Authorized Field Change

AFC G-06913R2

Subject: Meritor Rear Tandem Axle Adjuster Lock Screw Breakage

Retrofitting an Additional Adjusting Ring Lock Capscrew on Certain Meritor RT-40-145 Series Tandems (Rear-Rear Axle Only) Built Between March 15, 2004, and February 2, 2005

Figure 1

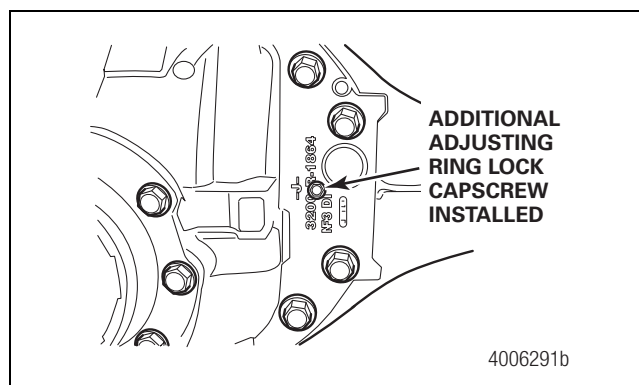
Inspect the carrier flange surface to determine if an additional adjusting ring lock capscrew has been installed. Figure 1 shows a carrier flange with an additional adjusting ring lock capscrew already installed.

Figure 2

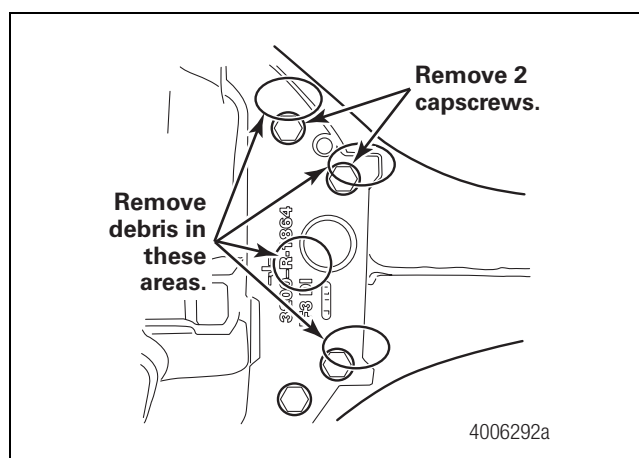
1. Wear safe eye protection.
2. Park the vehicle on a level surface. Block the wheels to prevent the vehicle from moving.
3. Remove grease and debris from the carrier flange surfaces of the rear-rear axle. The drill guide must be installed onto a clean surface. Figure 2.

4. Remove and retain two carrier-to-housing capscrews. They are the first two capscrews located above the centerline of the rear-rear axle on the driver's side. Set them aside to reinstall later in the procedure. Figure 2.

Figure 3

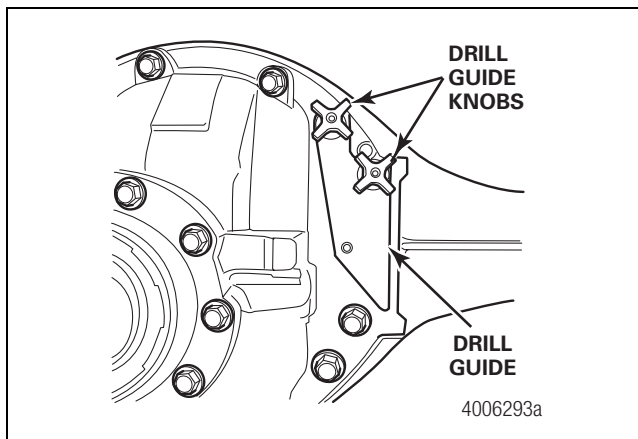
5. Clean the carrier-to-housing joint holes to remove excess sealant.
6. Install the drill guide onto the carrier by aligning the drill guide dowels with the carrier-to-housing holes. Hand-tighten the drill guide knobs to secure the drill guide to the carrier. Figure 3.

Figure 4

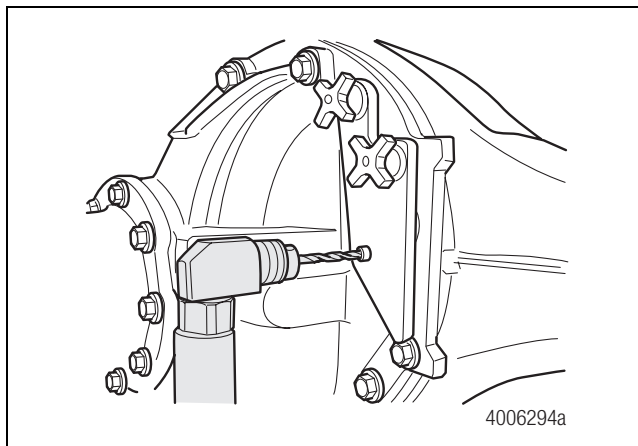
7. Verify that the three guide rest buttons are secure against the carrier face before drilling.
8. Install the size "L" drill bit provided in the tooling kit into the drill chuck. Insert the size "L" drill bit into the drill guide bushing. Lubricate the size "L" drill bit and guide bushing to reduce heat and prolong tool life. Figure 4.

Figure 5

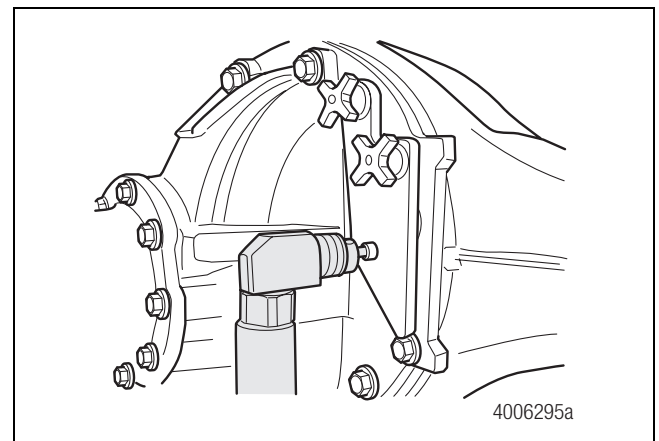
10. Check for adjusting ring lug clearance. With the size "L" drill bit still in the drill chuck, reinsert the size "L" drill bit into the drilled hole, until the drill chuck contacts the drill guide bushing. Figure 5.

- If you can insert the size "L" drill bit into the drilled hole until the drill chuck contacts the drill guide bushing, or the drill chuck comes within 0.5-inch (12.7 mm) or closer to the drill guide bushing: Proceed to Step 11.
- If you insert the size "L" drill bit and it contacts the adjusting ring, stopping when the drill chuck is 1-inch (25.4 mm) or more away from the drill guide bushing: Contact ArvinMeritor's OnTrac Technical Support Center at 866-668-7221 for assistance.

Figure 6

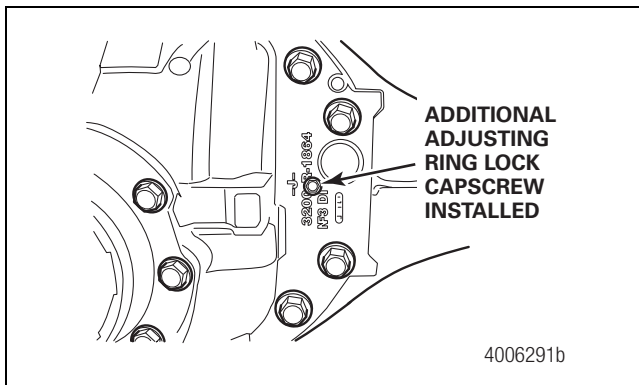
12. Apply Loctite® 242 threadlocker to the self-tapping adjusting ring lock capscrew provided in the kit. Install the adjusting ring lock capscrew into the drilled hole and tighten it to 25 lb-ft (34 N•m). Figure 6. **ⓘ**
